# TECHNICAL BULLETIN

LT310-001

## **SECTION: 310-01 (Fuel Delivery System - 19)**

Discovery II Td5 Poor Starting/Noisy Fuel Pump

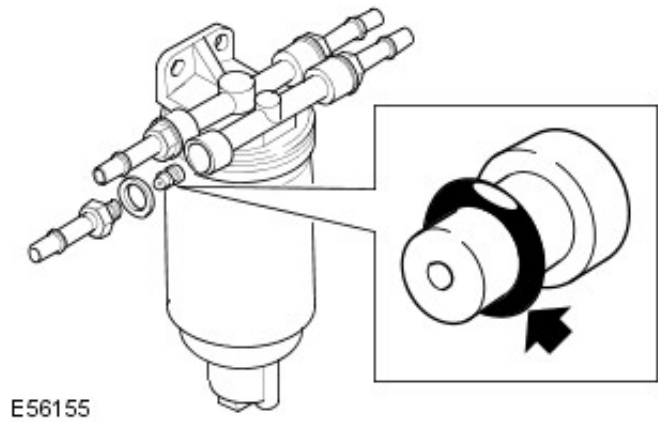
**Cause:** The O-ring seal on the fuel filter air bleed valve may be split, allowing air into the fuel system (If air is being introduced into the fuel system, it will make the primary fuel pump sound noisy).

**3** Remove the fuel return pipe from the fuel filter (white coded connector).

**4** Using a 19mm spanner, unscrew the brass adaptor from the assembly.

**5** Withdraw the air bleed valve from inside the brass fitting. Inspect the O-ring and plastic body for splits and damage.

**6** If the O-ring is damaged, renew parts provided in the service repair kit.
